Model Nakamichi CR-7/7A/7E/70
 (Discrete Head Cassette Deck)
 Serial No. from A13008677 -
 Subject Modification of Record Eq.
Amp. Circuit

No. OOD-M-0298 (1/3)
 Date 22 May 1987

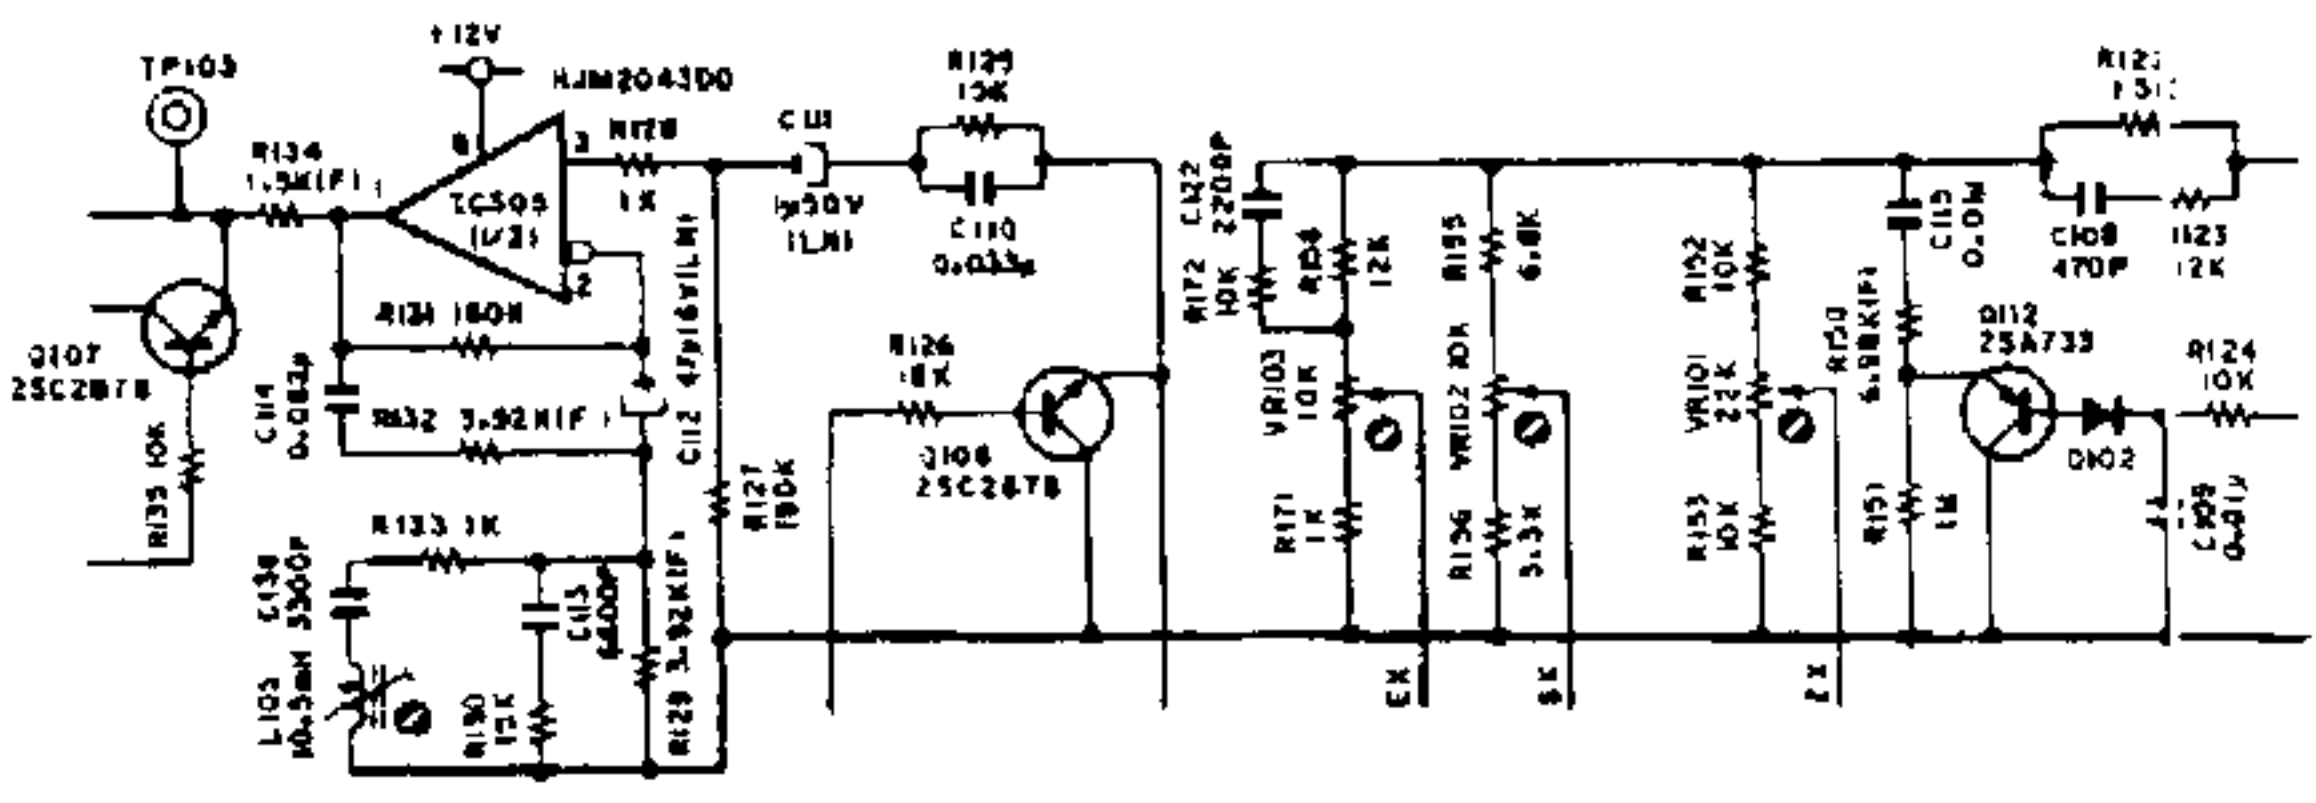
When a cassette tape with raised response at high frequencies (above 15 kHz) is used, the problem is not severe if the tape requires small bias current, such as Type I. However, when the cassette tape requires large bias current, such as Type II or IV, considerable overbias must be applied to make the 15 kHz response flat. Such overbias would have adverse effects, even on level calibration. The result would be a decrease in 1 kHz - 10 kHz response, particularly noticeable if C-type Dolby NR is selected.

Fig. 1

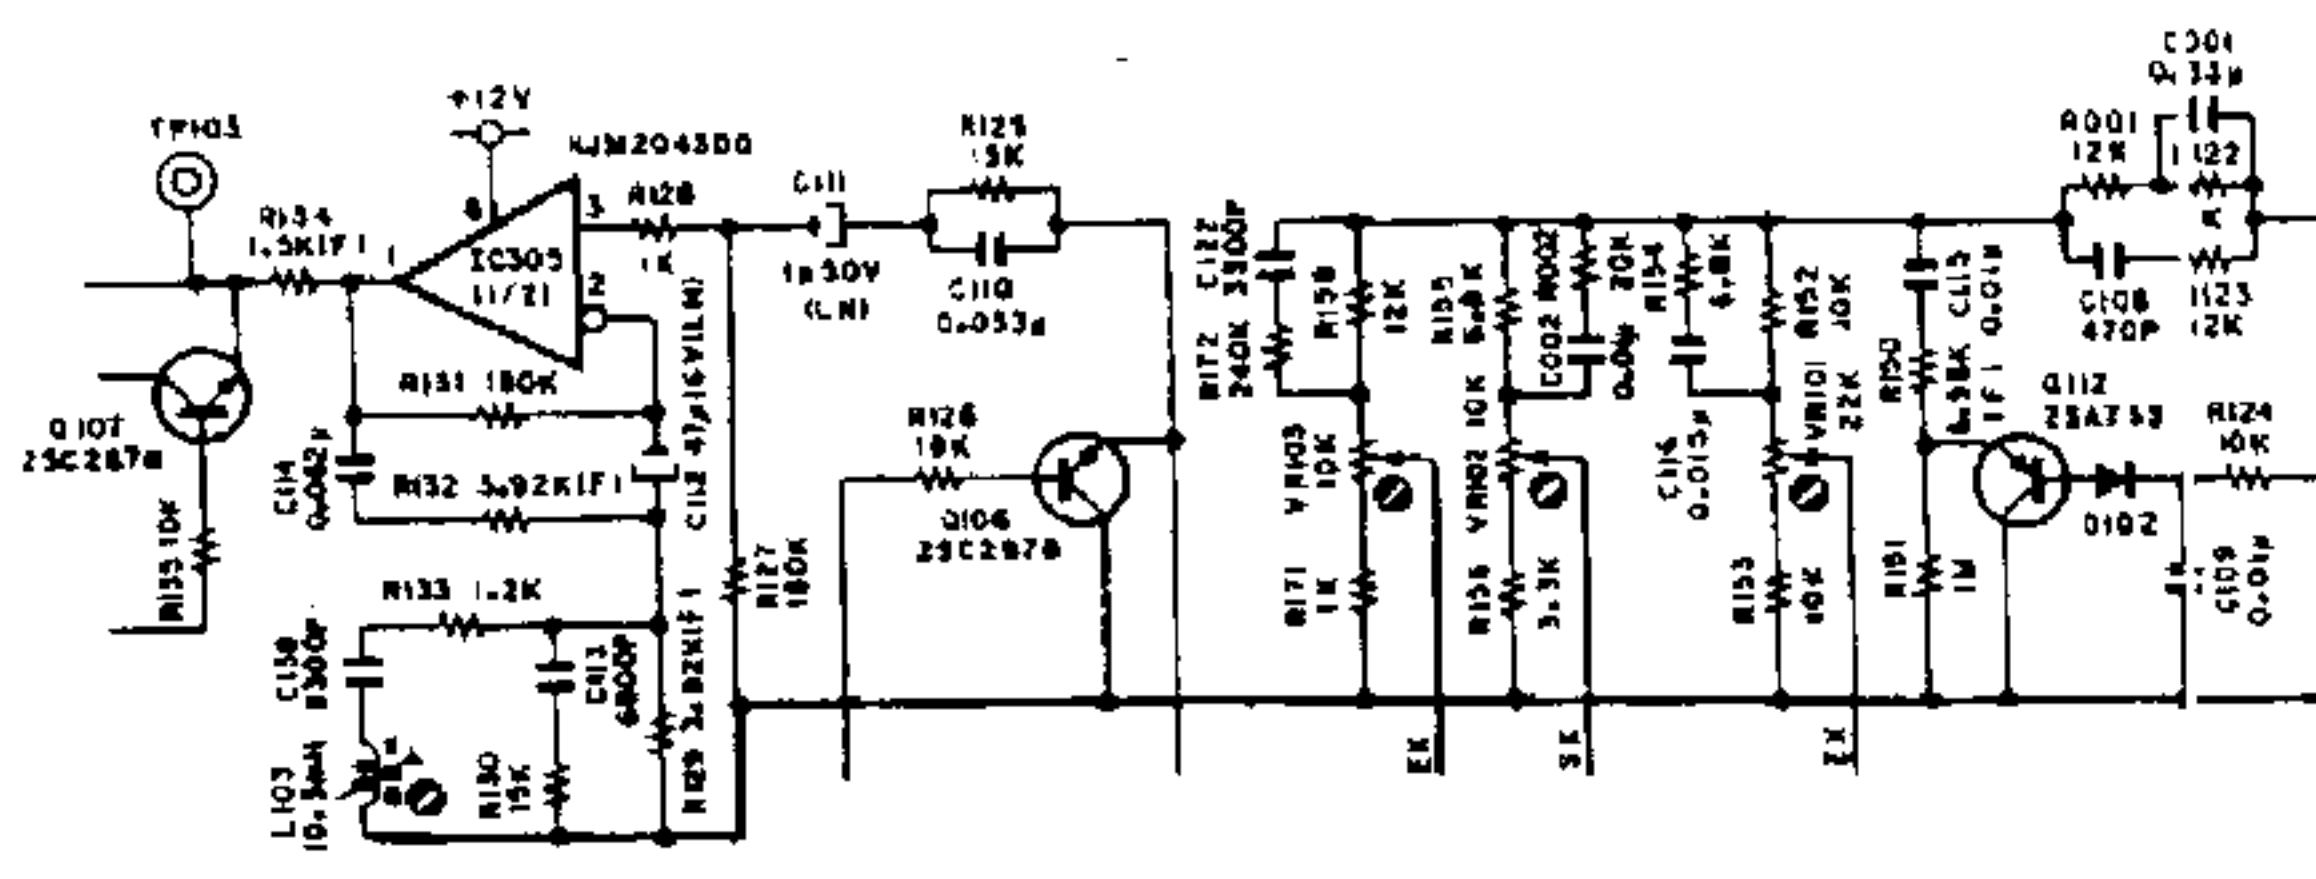
The following parts have been modified in the Main P.C.B. Ass'y.
Refer to Fig. 1.

<u>Ref. No.</u>	<u>Current Part No.</u>	<u>New Part No.</u>	<u>Description</u>	<u>Q'ty</u>
	BA05932A	BA05932A	Main P.C.B. Ass'y	1
(Rec. Eq. Amp.)				
R133,233	OB09677A	-	Carbon Resistor 1K 1/6W J	2
R133,233	-	OB09679A	Carbon Resistor 1.2K 1/6W J	2
(Rec. Cal.)				
R001,003	(None)	OB09703A	Carbon Resistor 12K 1/6W J	2
R002,004	(None)	OB09708A	Carbon Resistor 20K 1/6W J	2
R003,002	OB09705A	-	Carbon Resistor 15K 1/6W J	2
R122,222	-	OB09677A	Carbon Resistor 1K 1/6W J	2
R154,254	(None)	OB09697A	Carbon Resistor 6.8K 1/6W J	2
R172,272	OB09701A	-	Carbon Resistor 10K 1/6W J	2
R172,272	-	OB09732A	Carbon Resistor 240K 1/6W J	2
C001,003	(None)	OB41304A	Metalized Mylar Capacitor 0.33μ 50V J	2
C002,004	(None)	OB05681A	Mylar Capacitor 0.01μ 50V J	2
C116,216	(None)	OB41096A	Mylar Capacitor 0.015μ 50V J	2
C122,222	OB01802A	-	Mylar Capacitor 2200P 50V J	2
C122,222	-	OB41088A	Mylar Capacitor 3300P 50V J	2

Fig. 2 (Main P.C.B. Ass'y)

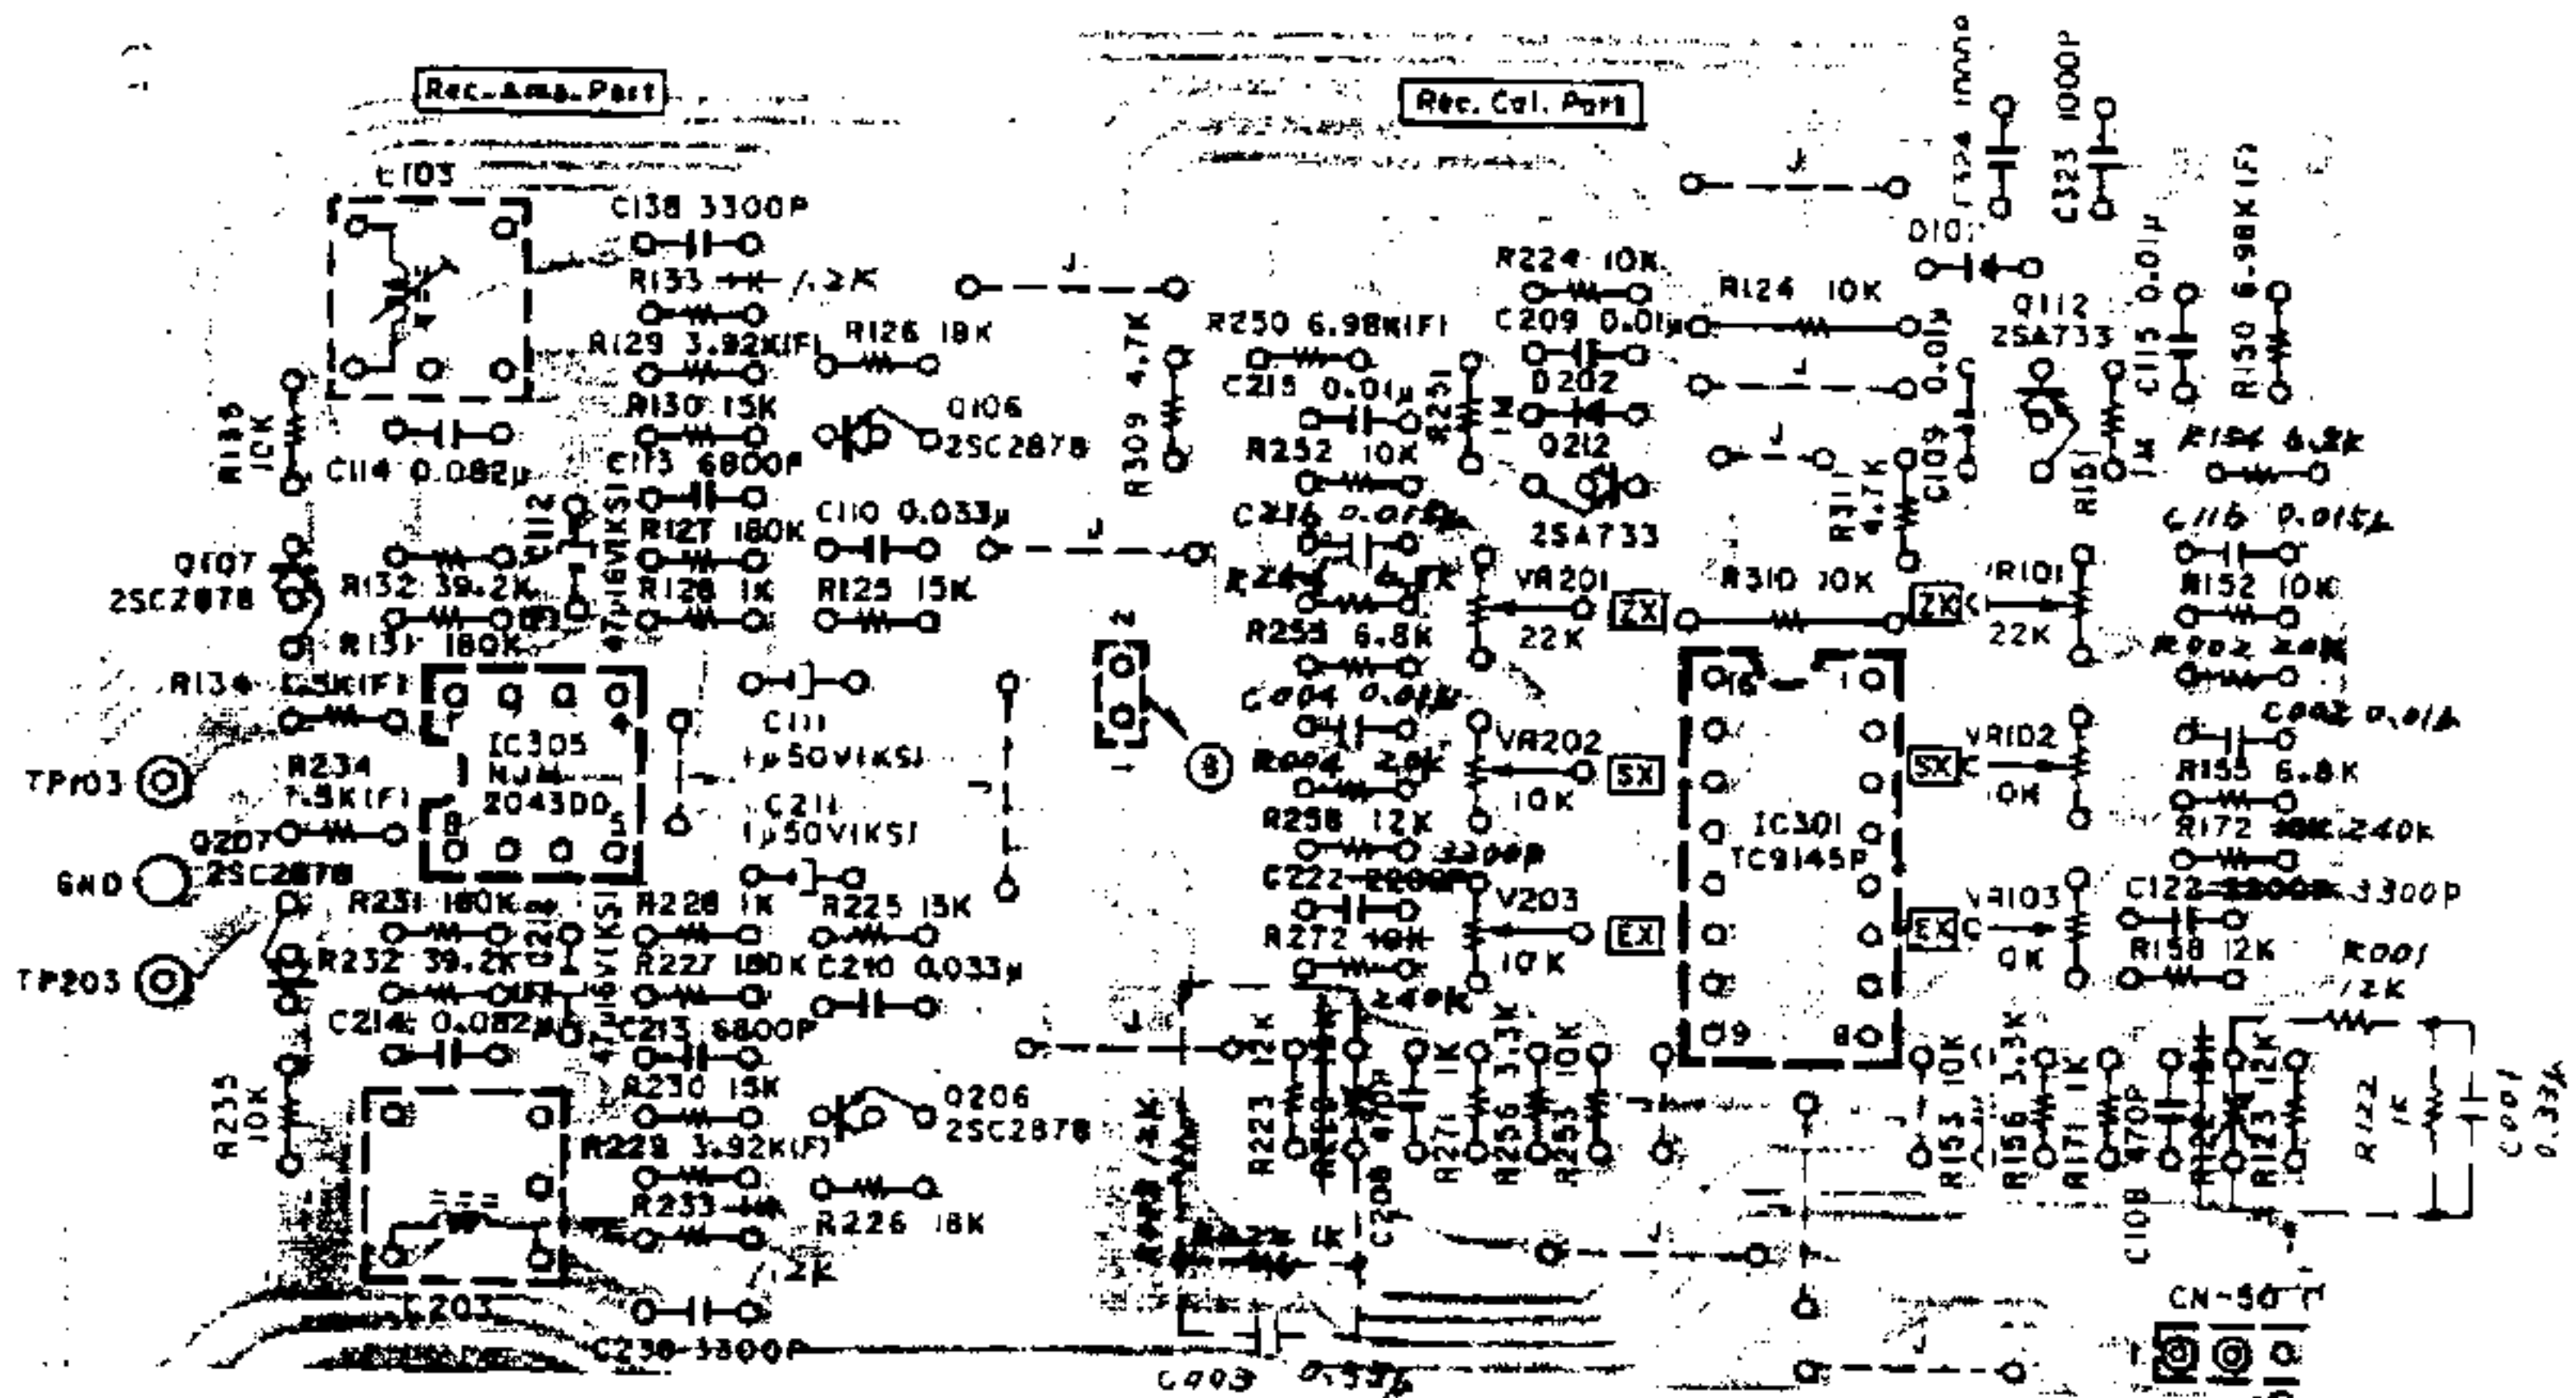
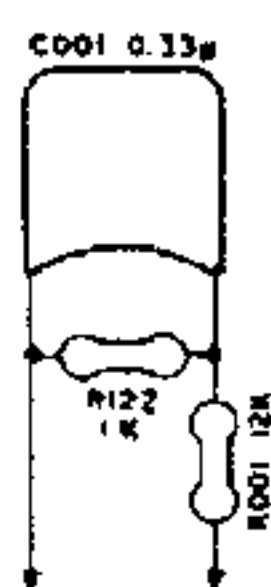
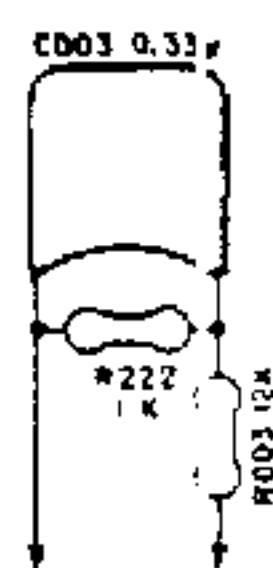
Refer to Fig. 2.

- (1) Remove R133, 233 (1 K).
- (2) Remove R122, 222 (15 K).
- (3) Remove R172, 272 (10 K).
- (4) Remove C122, 222 (Mylar Capacitor 2200P).
- (5) Mount R133, 233 (1.2 K).
- (6) Mount R172, 272 (240 K).
- (7) Mount C122, 222 (Mylar Capacitor 3300P).
- (8) Connect C001, 003 (Metalized Mylar Capacitor 0.33 μ), R122, 222 (1 K) R001, 003 (12 K) as follows and insert them into the places where R12 and R222 were mounted,

- (9) Mount R154, 254 (6.8 K).
- (10) Mount C116, 216 (Mylar Capacitor 0.015 μ).
- (11) Mount R002, 004 (20 K).
- (12) Mount C002, 004 (Mylar Capacitor 0.01 μ).
- (13) Perform re-adjustment using new reference tapes.
